OWNER:  شرکت سست و سوبی توهم ایران (سایه و شیشه)	BUSHEHR PETROCHEMICAL COMPANY MEG PLANT							EPC CONTRACTOR:  Chagalesh-Enerchimi-Steam Joint Venture BUPC-MEG PLANT PROJECT	
	HAZOP REPORT							 Contract No : 52-98/445	
MC :  شرکت سست و سوبی توهم ایران (سایه و شیشه)	Project	Area	Phase	Unit	Dis.	Doc.	Seq.	Contract No : 52-98/445	
Owner Document Number: 17811-80	BU	20	VD	303	IN	REP	0106	Rev.:	Page
								01	1 of 49

**REPORT NO.
1189837.01.22**

**BUPC MEG Plant HAZOP & SIL Report –
N2 and Air Compressor
Detailed Design**

BV Project Title: BUPC MEG PLANT HAZOP & SIL study
DD - Compressors

DRAWING TITLE: 17811-03 P&ID FOR NITROGEN GAS BOOSTER

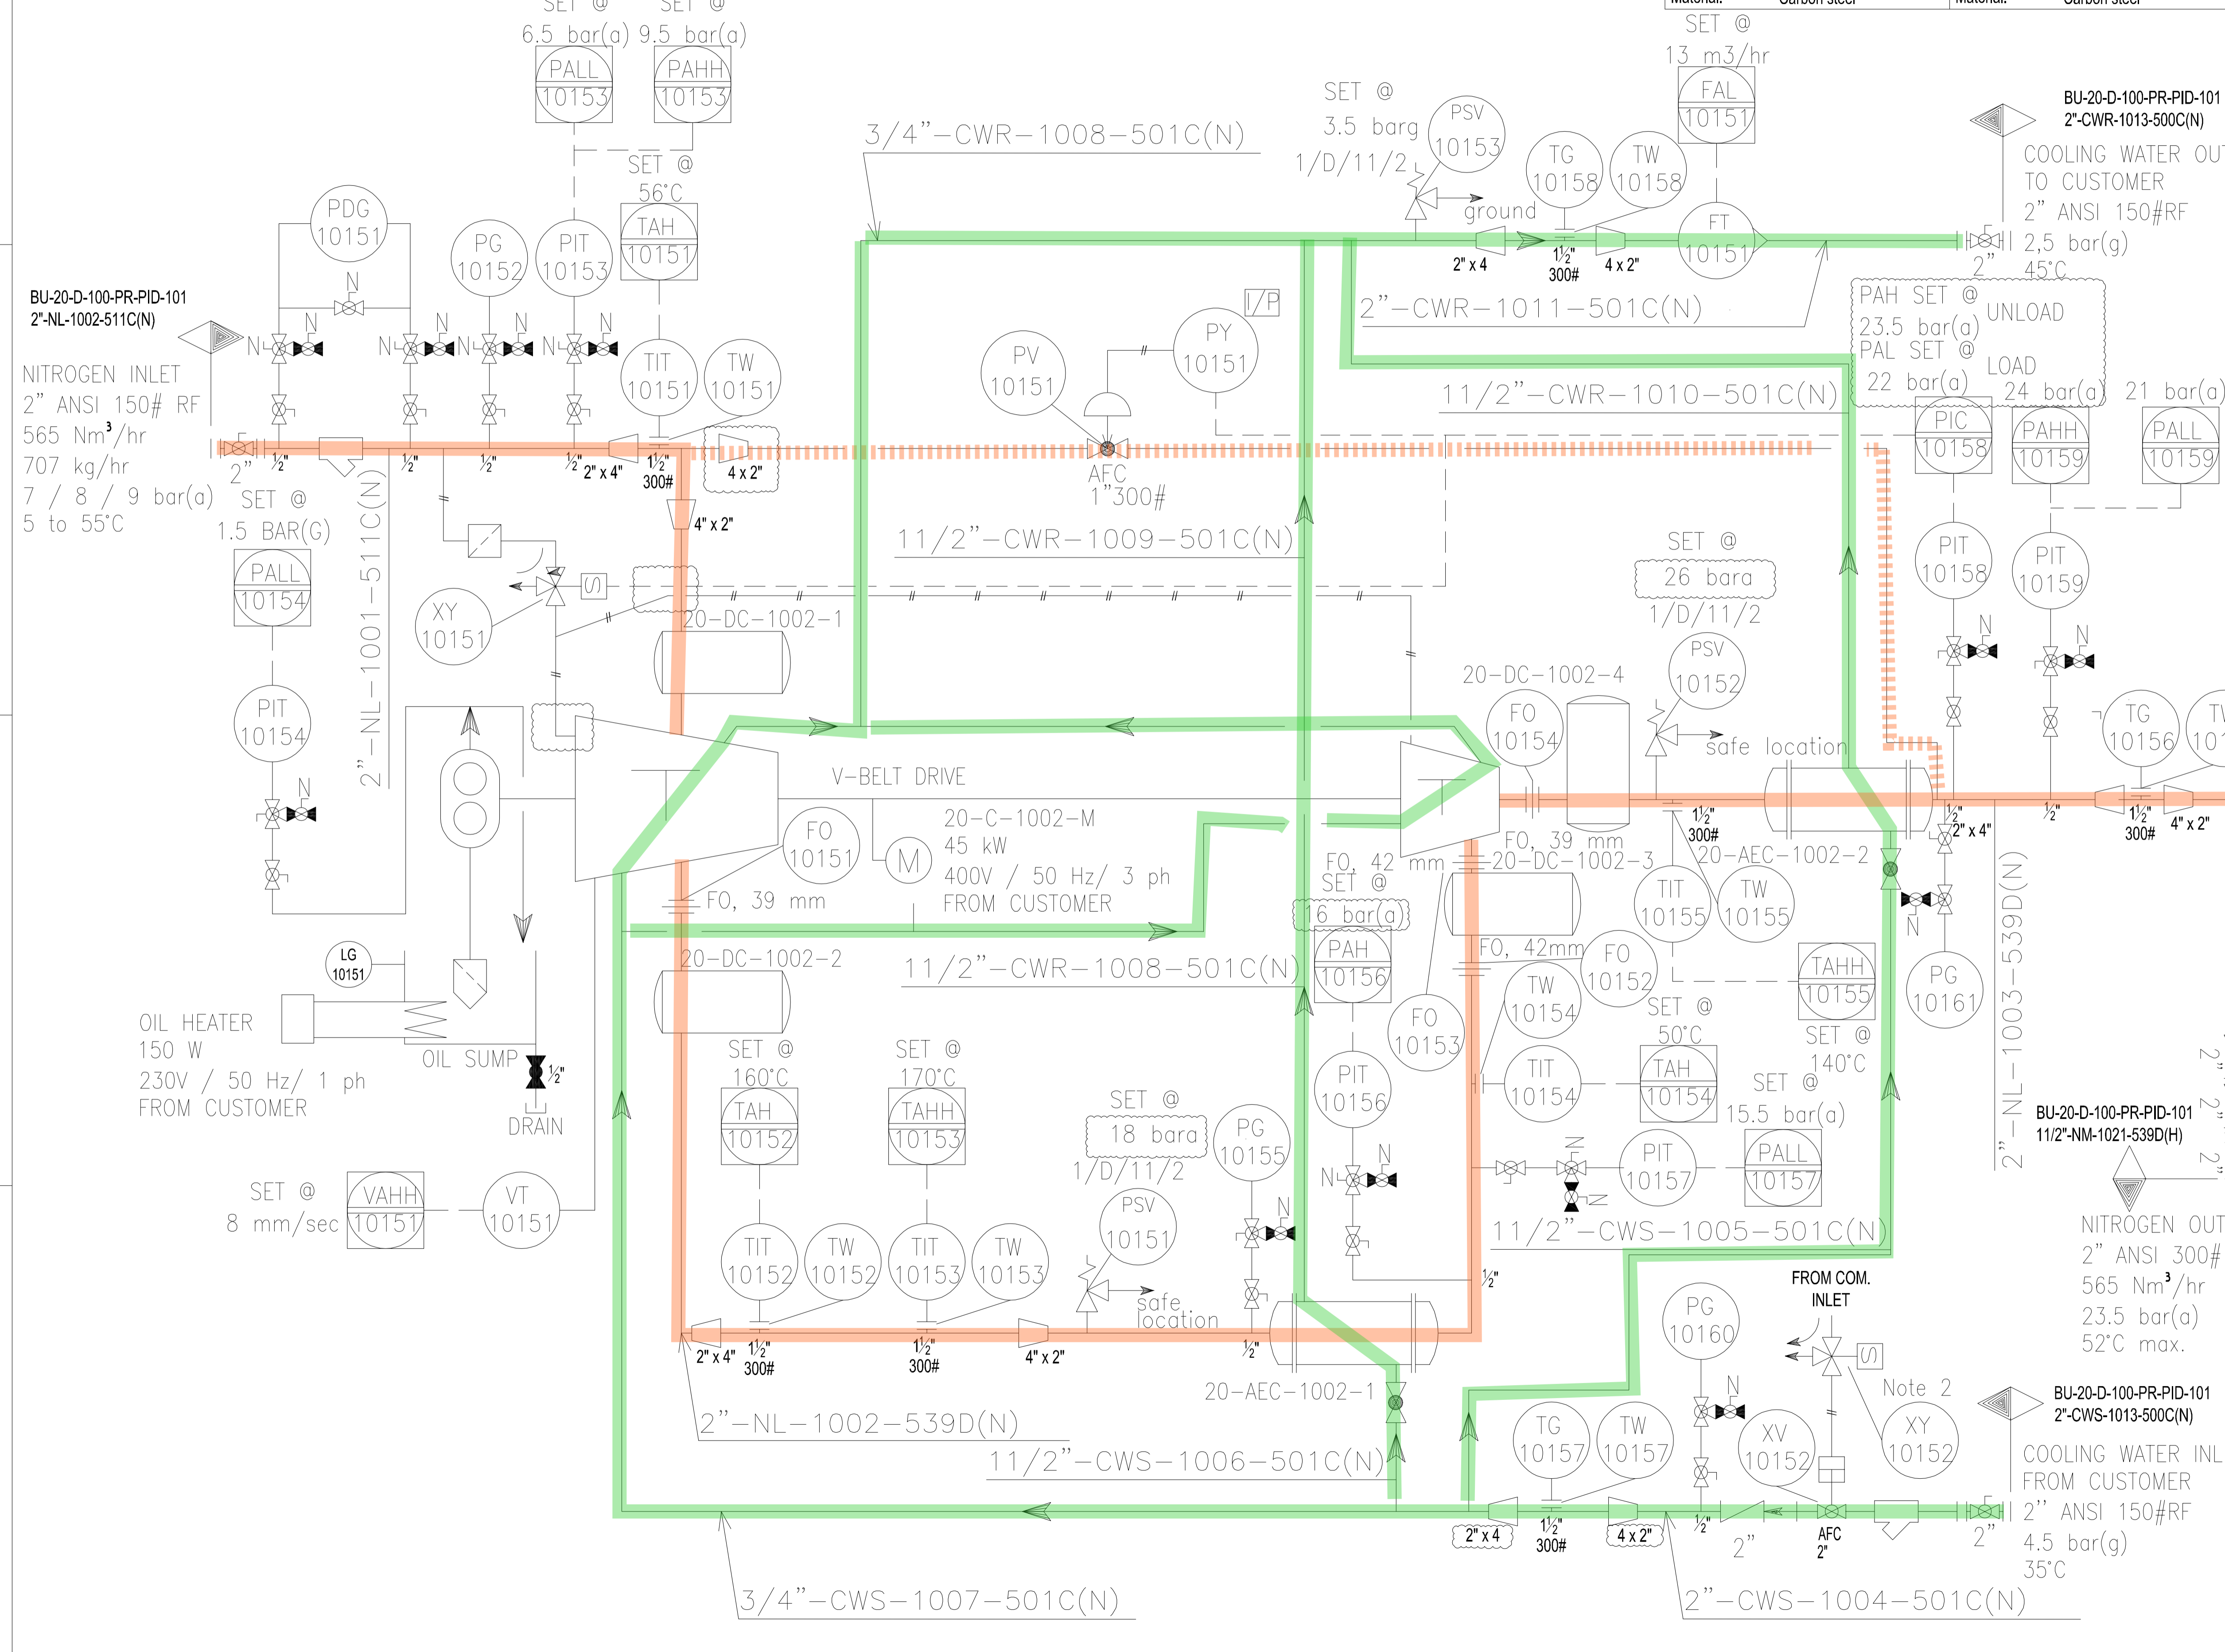
Node 1: Nitrogen

Node 2: Cooling Water N2 Compressor

01.1.1.1	Flow	No / Not	No/Less Flow	No nitrogen supply from Plant	1. No Supply to the compressor leading to underpressure at the suction side of the compressor. Worst case is if recycle line is closed. No vacuum is expected, however the 1stage discharge pressure will decrease. Increase of temperature of the second stage exceeding the design temperature of the Compressor. Less supply to the end users. Vibrations of the axis of the compressor is possible. No loss of containment. No hazardous consequence. Asset damage (L) only 2nd stage < 5000 US\$.	L	1. PIT-10153-PALL to Trip 20-C-1002 (UCP ESD) 2. PIT-10159-PALL to Trip 20-C-1002 (UCP ESD) 3. TIT-10155-TAHH to trip 20-C-1002 (UCP ESD)	1	3	SIL 0	1. PIT-10153-PALL to Trip 20-C-1002 (UCP ESD) 2. PIT-10159-PALL to Trip 20-C-1002 (UCP ESD) 3. TIT-10155-TAHH to trip 20-C-1002 (UCP ESD)	3	No action

01.1.2.1	Flow	No / Not	No/Less Flow	Blocked Filter/Strainer in supply line (inlet)	1. No Supply to the compressor leading to underpressure at the suction side of the compressor. Worst case is if recycle line is closed. No vacuum is expected, however the 1stage discharge pressure will decrease. Increase of temperature of the second stage exceeding the design temperature of the Compressor. Less supply to the end users. Vibrations of the axis of the compressor is possible. No loss of content. No hazardous consequence. Asset damage (L) only 2nd stage < 5000 US\$.		1. PIT-10153-PALL to Trip 20-C-1002 (UCP ESD) 2. PIT-10159-PALL to Trip 20-C-1002 (UCP ESD) 3. TIT-10155-TAHH to trip 20-C-1002 (UCP ESD)	1	3	SIL 0	1. PIT-10153-PALL to Trip 20-C-1002 (UCP ESD) 2. PIT-10159-PALL to Trip 20-C-1002 (UCP ESD) 3. TIT-10155-TAHH to trip 20-C-1002 (UCP ESD)	3	No action

01.1.3.1	Flow	No / Not	No/Less Flow	Motor or V-belt Drive Failure Compressor 20-C-1002-M	1. No Supply to the end user. Discharge pressure of the Compressor will decrease. No supply to the end users. No hazardous consequence. No asset consequences		1. PIT-10159-PALL to Trip 20-C-1002 (UCP ESD) 2. PIT-10154-PALL to Trip 20-C-1002 (UCP ESD) (lube oil pressure low will stop the compressor)

01.1.4.1	Flow	No / Not	No/Less Flow	Mechanical Failure 1st stage Compressor 20-C-1002	1. Worst case is piston failure. No Supply to the end user. Loss of containment is possible. Maximum release < 0.2 kg/h (707 kg/h /) No suffocation to people is expected (open area, 4 sides open). Compressor may catch fire, damage of compressor. Hurting people is possible. Severity S=S2; S2 is equal to C A. Asset damage (L) is ca. 50 k. US\$ L=S1; Most severe is people risk. Note: Regular maintenance will reduce this risk.	S	1. PIT-10159-PALL to Trip 20-C-1002 (UCP ESD) 2. VT-10151-VAHH to Trip 20-C-1002 (UCP ESD)	2	3	SIL 1	1. PIT-10159-PALL to Trip 20-C-1002 (UCP ESD) 2. VT-10151-VAHH to Trip 20-C-1002 (UCP ESD) SIL1 SIF in SIS	2	No action

01.1.6.1	Flow	No / Not	No/Less Flow	Mechanical Failure 2nd stage Compressor 20-C-1002	1. Worst case is piston failure. No Supply to the end user. Loss of containment is possible. Maximum release < 0.2 kg/h (707 kg/h /) No suffication to people is expected (open area, 4 sides open). Compressor may catch fire, damage of compressor. Hurting people is possible. Severity S=S2 S2 is equal to C A. Asset damage (L) is ca. 50 k. US\$ S=S1; Most severe is people risk. Note: Regular maintenance will reduce this risk.	S	1. PIT-10159-PALL to Trip 20-C-1002 (UCP ESD) 2. VT-10151-VAHH to Trip 20-C-1002 (UCP ESD)	2	3	SIL 1	1. PIT-10159-PALL to Trip 20-C-1002 (UCP ESD) 2. VT-10151-VAHH to Trip 20-C-1002 (UCP ESD) SIL1 SIF in SIS	2	No action

01.1.8.1	Flow	No / Not	No/Less Flow	Blocked flow by check valves at outlet fails closed, also in case of lower pressure downstream.	1. No supply to the end user. Increased pressure and temperature in the second stage of the compressor. Flow will be recycled to the inlet. Recycle line will be designed for full flow. No consequences.		1. PIT-10159-PAHH to trip 20-C-1002 (UCP ESD) 2. PSV-10152 @ 26 bara 3. TIT-10155-TAHH to trip 20-C-1002 (UCP ESD)

01.1.9.1	Flow	No / Not	No/Less Flow	Blocked flow downstream (no take off)	1. No supply to the end user. Increased pressure and temperature in the second stage of the compressor. Flow will be recycled to the inlet. Recycle line will be designed for full flow. No consequences.		1. PIT-10159-PAHH to trip 20-C-1002 (UCP ESD) 2. PSV-10152 @ 26 bara 3. TIT-10155-TAHH to trip 20-C-1002 (UCP ESD)

01.2.1.1	Flow	More	More/High Flow	More flow over the recycle line by 'Fail Opened AFC PV-10151 or control failure to opened valve in case AFC should be NOT fully opened.	1. Decreased pressure and temperature in the second stage of the compressor. Less supply to the plant/ end user. No hazardous consequence; No asset consequence.		1. PIT-10159-PALL to trip 20-C-1002 (UCP ESD)

02.1.1.4	Flow	No / Not	No/Less Flow	No Cooling Water supply from Plant	Overheating of cooling water in aftercooler 20-AEC-1002-2. Exceeding of the design temperature of the tubes inside the aftercooler (95 deg C). Maximum temperatures of the cooling water (140 deg C -equal to uncooled nitrogen- can be reached. Boiling of water may start at ca. 120 deg C. Tube rupture is possible. Nitrogen induced into the cooling water and exceeding also the design pressure of the cooling water system. Loss of containment is possible. Maximum release with full rupture- 0.2 kg/s (707 kg/h /). Full rupture is not expected. No suffocation of people is expected (open area, 4 sides open). Remote suffocation risk to people is possible (safety distance is ca. 1-2 meters. Severity S=S2 (S2 is equal to C A according risk matrix) Asset damage (L) is ca. 10 k. US\$ L=S1; Most severe risk is people risk (S=S2).	S	1. TIT-10155-TAHH to Trip 20-C-1002 (UCP ESD) 2. FT-10151-FAL to Trip 20-C-1002 by operator (only 1 alarm is counting for a risk reduction) 3. PSV-10153 @3.5 barg to ground	2	3	SIL 1	1. TIT-10155-TAHH to Trip 20-C-1002 (UCP ESD) <i>SIL 1 SIF in SIS</i> 2. FT-10151-FAL to Trip 20-C-1002 by operator (only 1 alarm is counting for a risk reduction) 3. PSV-10153 @3.5 barg to ground (RRF=100)	4	No action

02.1.1.5	Flow	No / Not	No/Less Flow	No Cooling Water supply from Plant	No Cooling of Compressor 20-C-1002. Not exceeding of the design temperature (170 deg C for valves, 210 deg C for casing and internal cooling water circuit); temperature in the discharge of the 1st stage or 2nd stage of the compressor may go up ca. 170 deg C. No loss of containment. No hazardous consequence. No Asset damage (L) is expected.		1. TIT-10155-TAH to Trip 20-C-1002 (UCP ESD) 2. FT-10151-FAL to Trip 20-C-1002 (UCP ESD)

DRAWING TITLE: 17811-03 P&ID FOR INSTRUMENT AIR COMPRESSOR

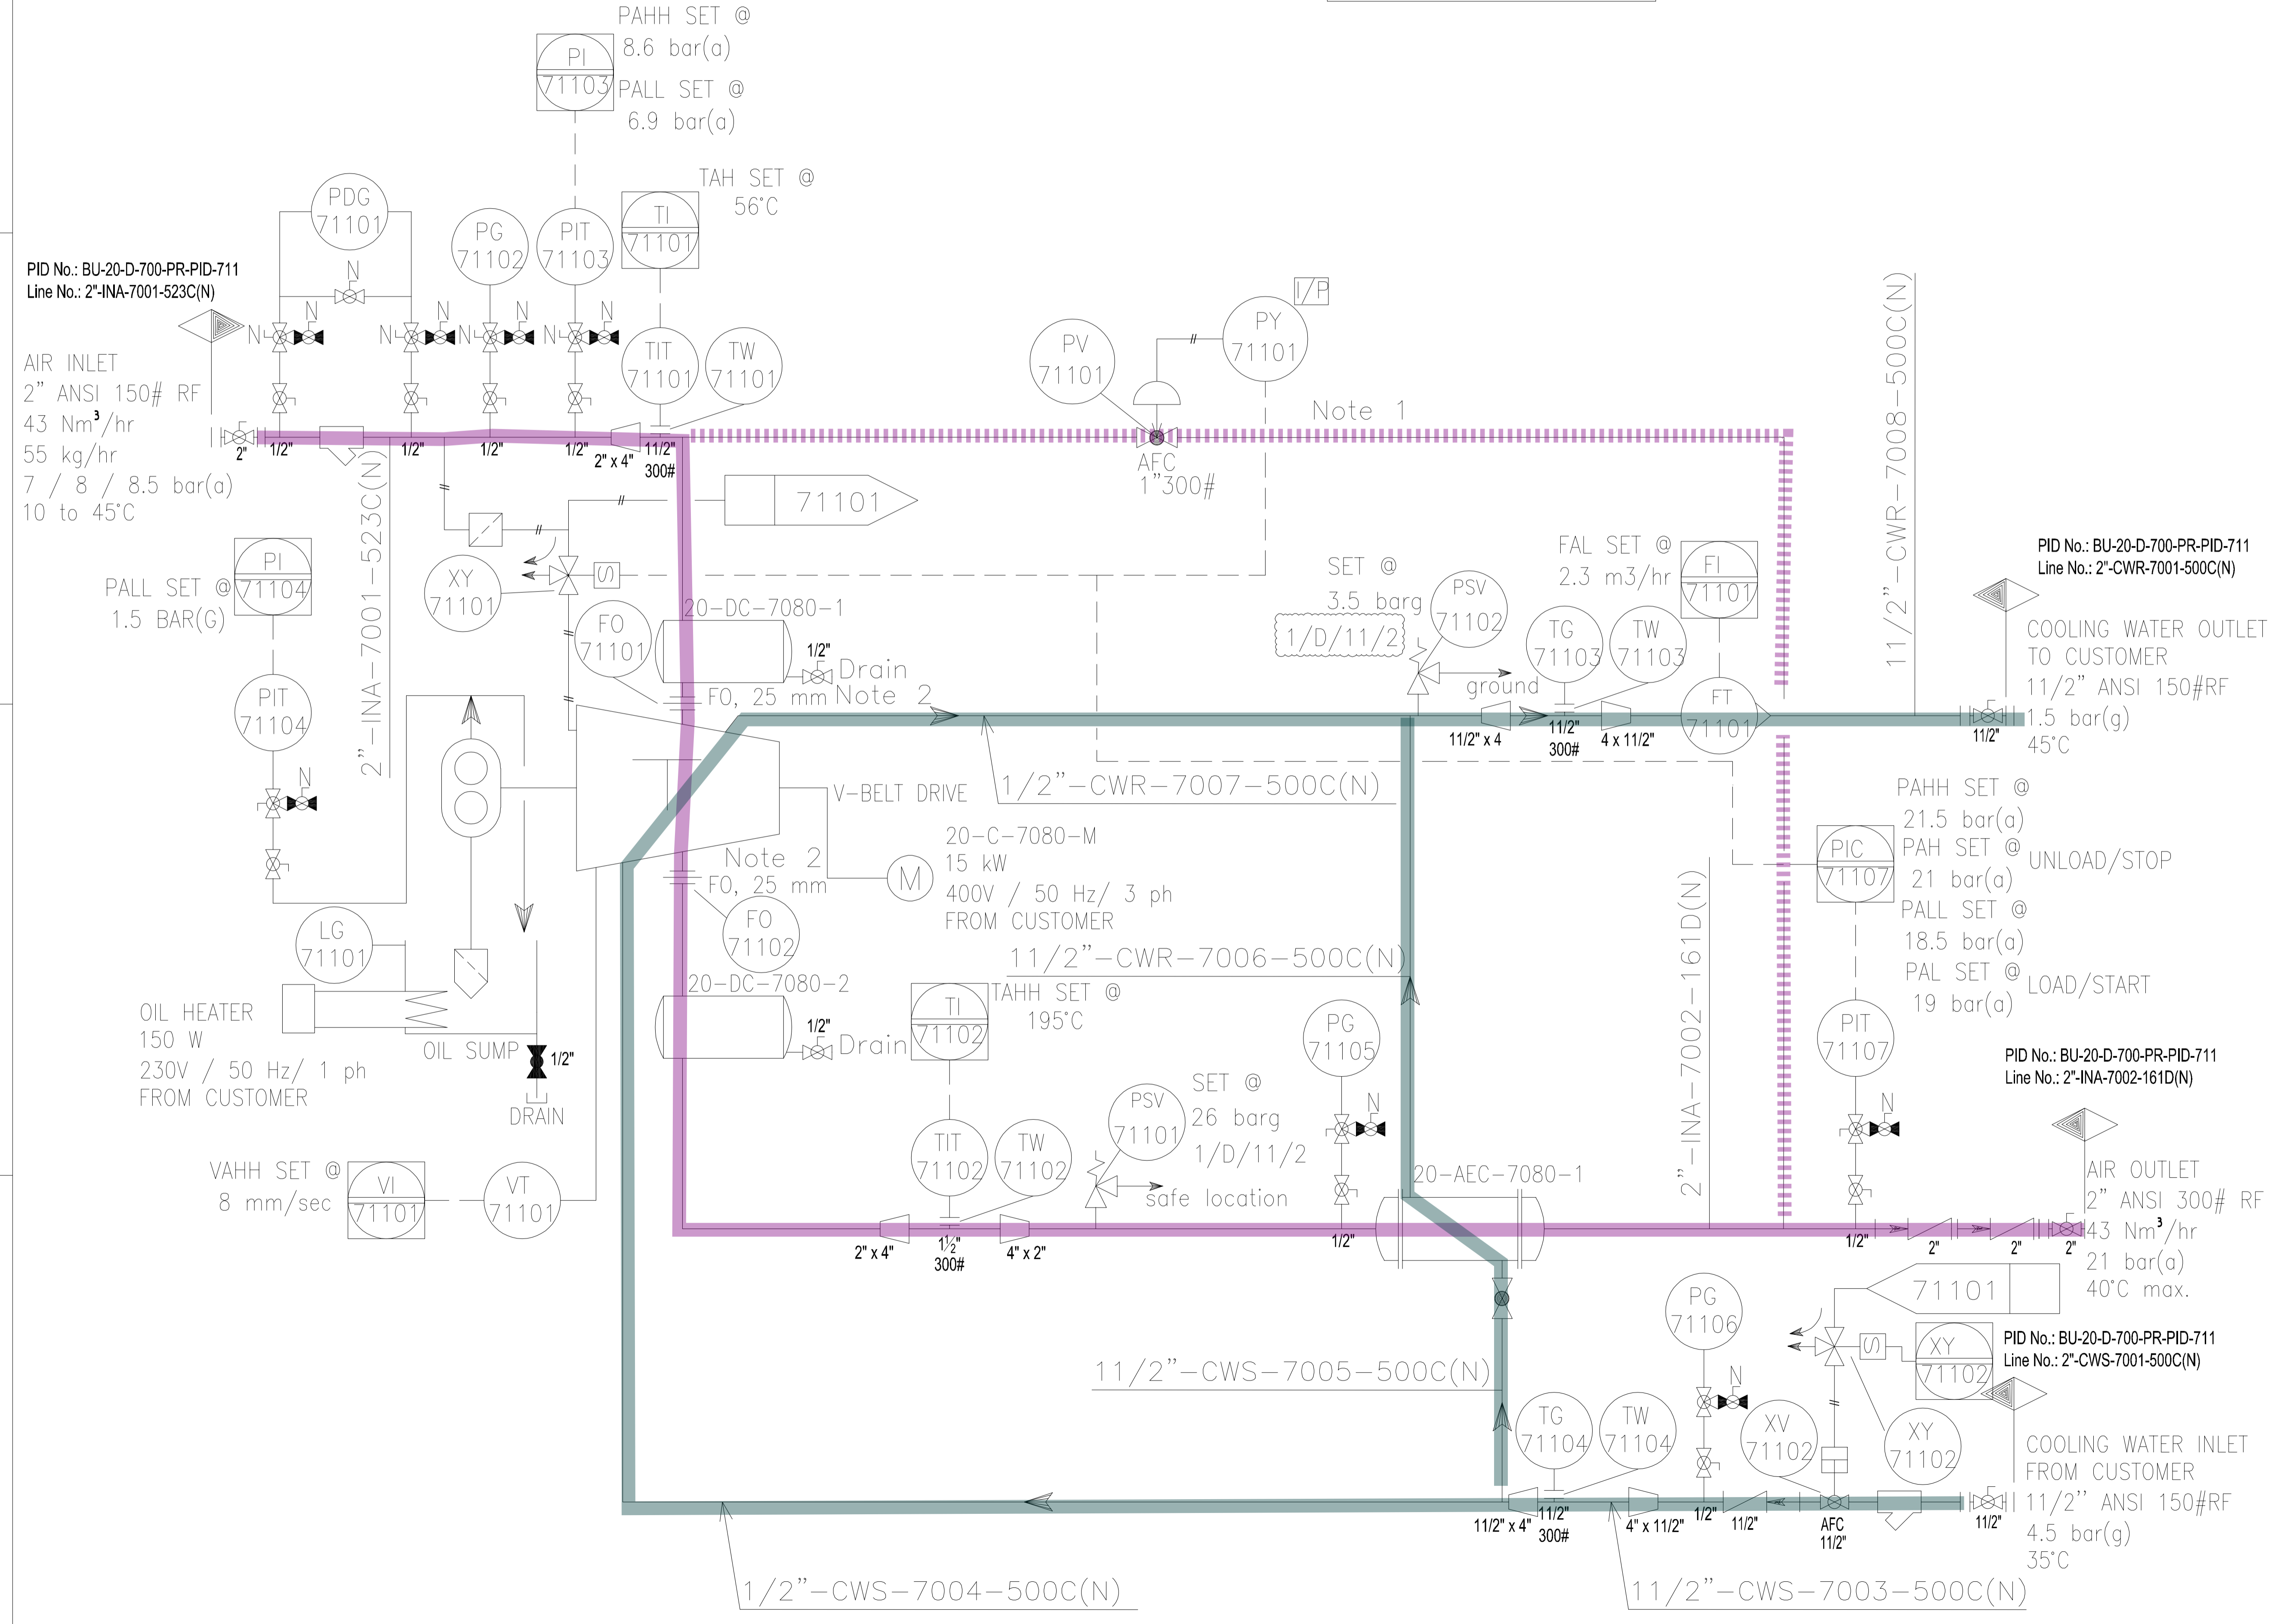
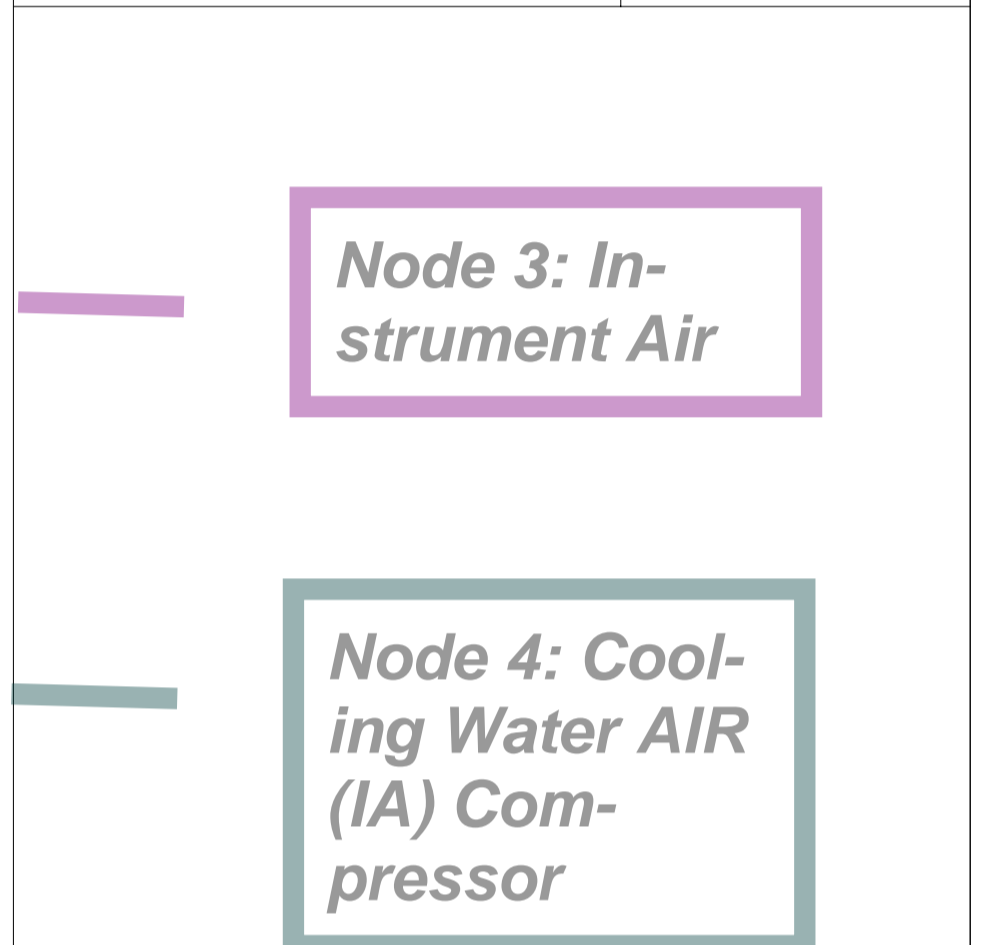
03.1.1.1	Flow	No / Not	No/Less Flow	No Air supply from Plant	1. No Supply to the compressor leading to underpressure at the suction side of the compressor. Worst case is if recycle line is closed. No vacuum is expected, however the discharge pressure will decrease. Increase of temperature of the first stage exceeding the design temperature of the Compressor. Less supply to the end users. Vibrations of the axts of the compressor is possible. No loss of containment. No hazardous consequence. Asset damage (L) < 5000 US\$.	L	1. PIT-71103-PALL to Trip 20-C-7080 (UCP ESD) 1. PIT-71107-PALL to Trip 20-C-7080 (UCP ESD) 3. TIT-71102-TAHH to trip 20-C-7080 (UCP ESD)	1	3	SIL 0	1. PIT-71103-PALL to Trip 20-C-7080 (UCP ESD) 1. PIT-71107-PALL to Trip 20-C-7080 (UCP ESD) 3. TIT-71102-TAHH to trip 20-C-7080 (UCP ESD)	3	No action

03.2.1.1	Flow	More	More/High Flow	More flow over the recycle line by 'Fail Opened AFC PV-71101 or control failure to opened valve in case AFC should be NOT fully opened.	1. Decreased pressure and temperature in the second stage of the compressor. Less supply to the plant/ end user. No hazardous consequence; No asset consequence.		1. PIT-71107-PALL to trip 20-C-7080 (UCP ESD)
